Town of Parker Community Development Department  
Development Review Division  
Attention: Amber Wood-Hicken

Application Type: **Site Plan – Non-Residential**  
Status: **First Referral**  
Application Name: Douglas 234 F6 AMD 2 L10B – Commercial Bldg  
Case/AP#: **SP25-021**  
Referral Received: April 7, 2025  
Comments Due: May 5, 2025

Review date: **April 25, 2025**  
Plan reviewer: **Randall L. Capra, [rcapra@parkeronline.org](mailto:rcapra@parkeronline.org)**  
Phone: 303.805.3163

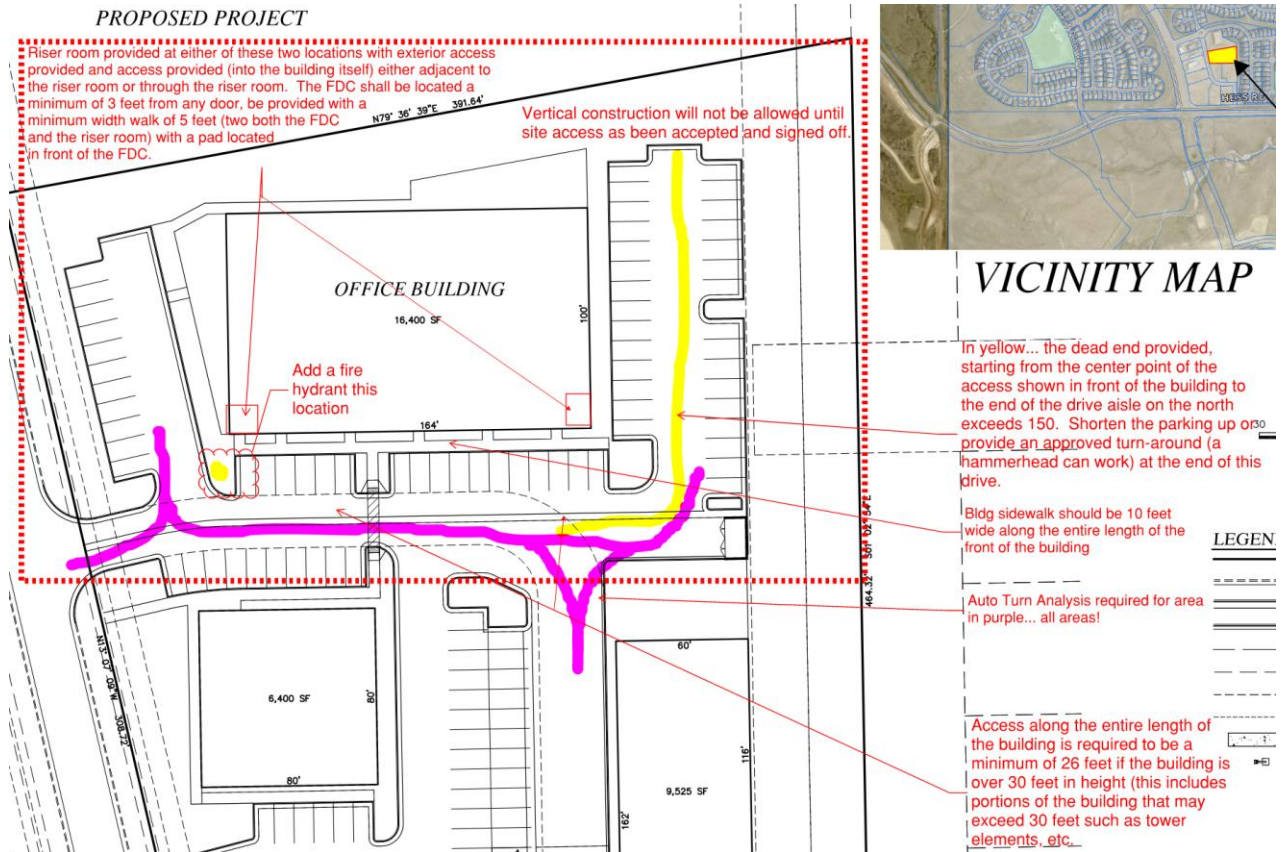
4. The applicant shall be aware that the internal access hydrant distribution was not planned to address the suppression needs for all commercial properties within this subdivision; this site requires the addition of one hydrant (to be located at the s/e corner island adjacent to the building... as required per NFPA 24 Section 7.2.3. Utility drawings are required to address this requirement.

The fire hydrant shall be provided within 40 feet of the building (specifically the riser room... with the water room shown on the north side of the building not being acceptable for this project). See the bullet points that must be addressed for the riser room and the utility drawings noted in item #5 below.

This issue was addressed on November 20, 2024. This document identified the location of two riser room locations that were deemed to be acceptable. The document also required that the applicant provide an auto turn analysis and fire hydrant. See a copy of the redlined document below. Note – the fire hydrant will be required to be located in the center island on the south side of the building now that a more complete site plan has been provided. See a snapshot of this document below (the constraints of the site are more obvious with the current submittal):

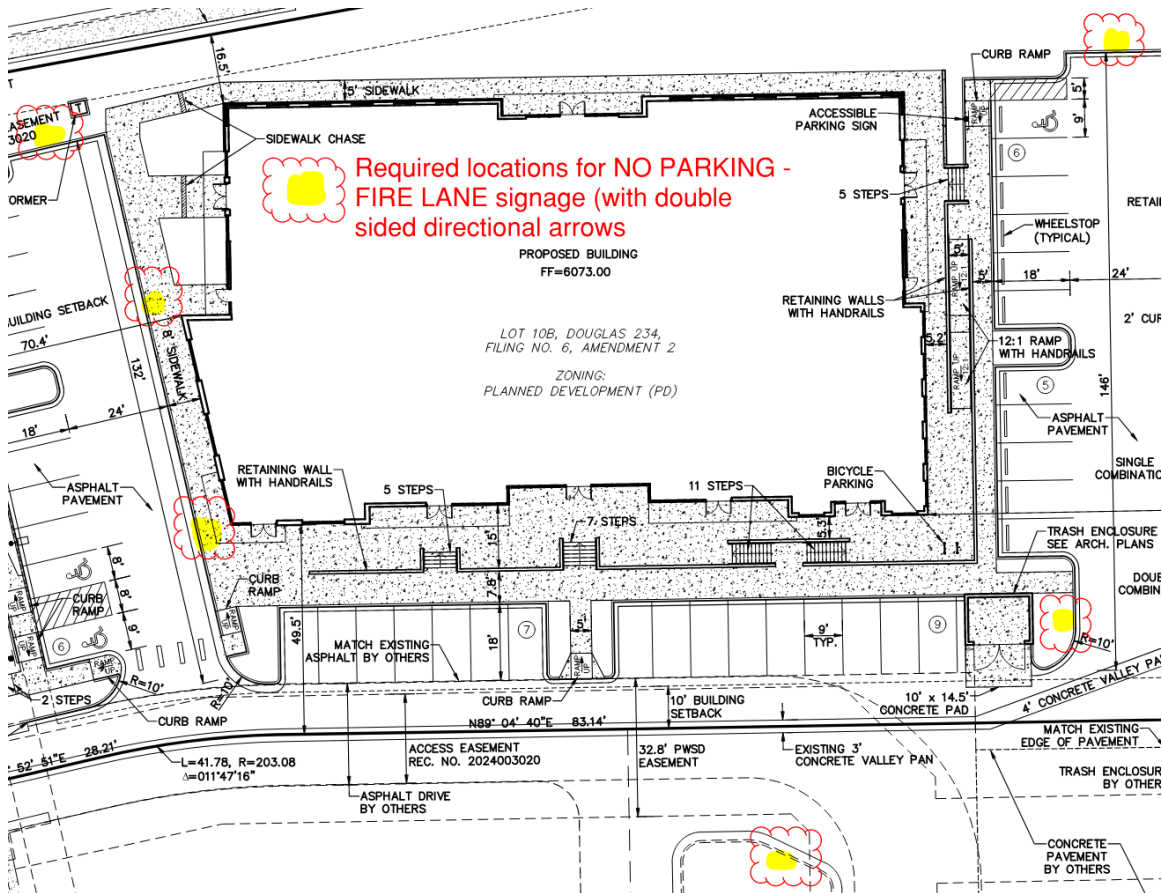
- An exterior door shall be provided into the riser room.
  - A door, either adjacent to the riser room or a door that provides immediate access into the building through the riser room shall be provided. **This issue has not been shown to be addressed with the current submittal although the requirement was addressed at length during the pre-application meeting... see below.**

- **A detail of the riser room is required to show how the room is to be laid out (arranged), that all clearances are met, and that exterior access has been provided into the riser room with the required access into the building. This is a requirement and will not be allowed to be deferred.**

- The location of the required fire department connection (FDC) shall be in the area of the riser room and required fire hydrant. The FDC shall be a minimum of 3 feet away from any door or architectural feature/column). The applicant shall provide a minimum 5-foot sidewalk from the emergency access lane to the riser room. Address this issue when resubmitting.
- The applicant shall provide a minimum 5 x 5 pad in the area where the FDC will be located outside of the riser room. Address this issue when resubmitting.
- While additional utilities are allowed to be located in the riser room, the additional utilities are not allowed to encroach in any of the required areas for either FACP or the riser. This is one of the reasons why the floor plan is required.

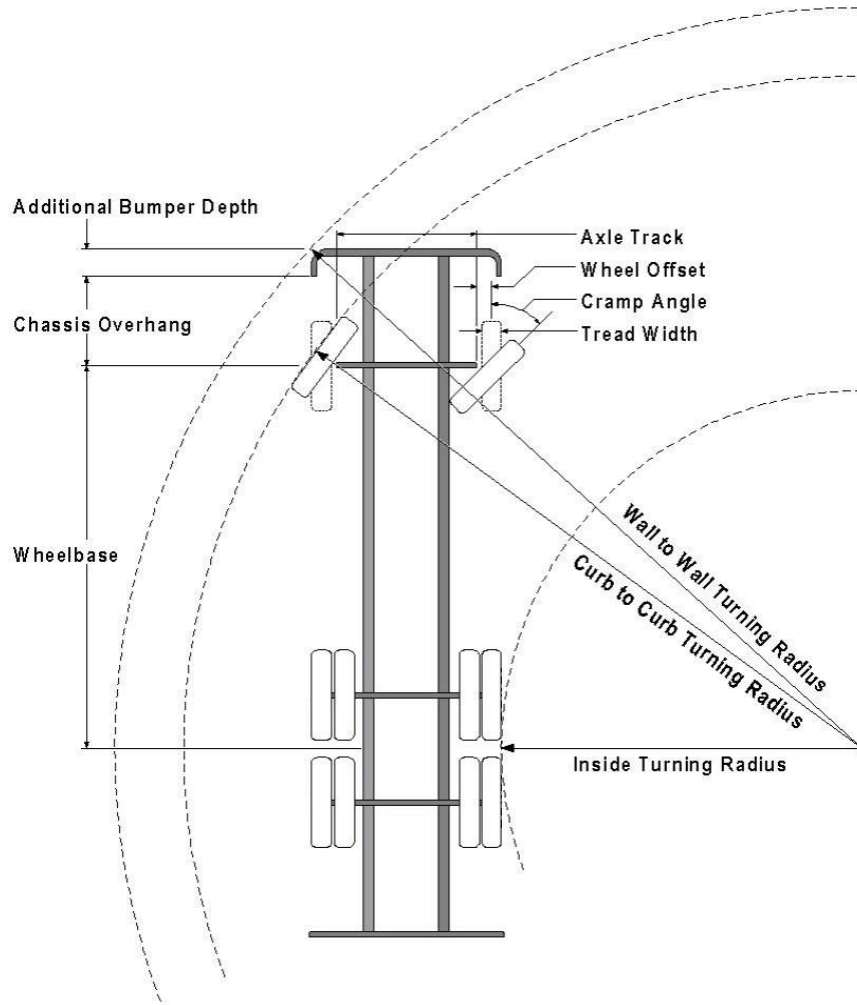
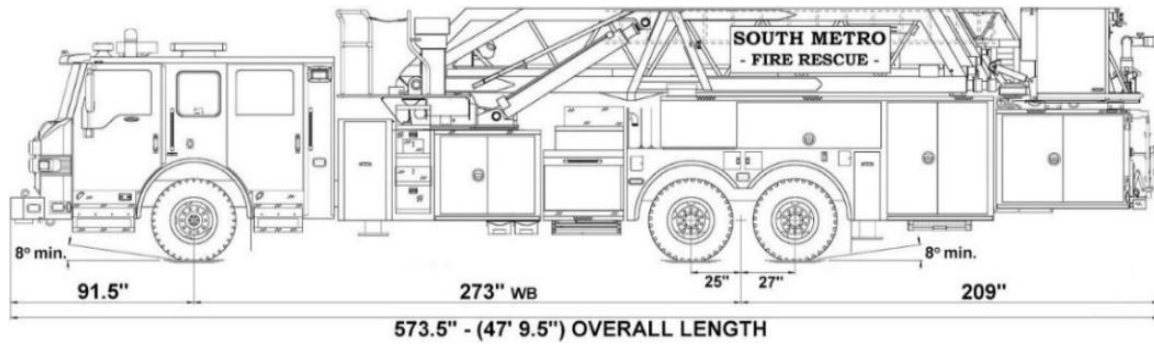
9. The applicant has not provided a signage plan; the signage plan shall address all signage including the requirement for NO PARKING – Fire Lane Signage. See the redlines below for location of required NO PARKING – FIRE LANE (with double sided directional arrows) signage in the location shown below;

Note - The Town of Parker requires that fire apparatus access roads meet the clear-width and weight-bearing standards of the jurisdiction in which the project is located. Roadways shall be designed to support the imposed weight of fire apparatus, 30-ton, two axle and 40-ton, three axle vehicles. **An unimpeded clear width of 26-feet shall be maintained at all times.** As such, any location where parked vehicles would obstruct this clear width requirement will require “NO PARKING – FIRE LANE” signage. *This signage shall be red on white. Update design criteria has been provided at the end of this document; ensure compliance when resubmitting.*
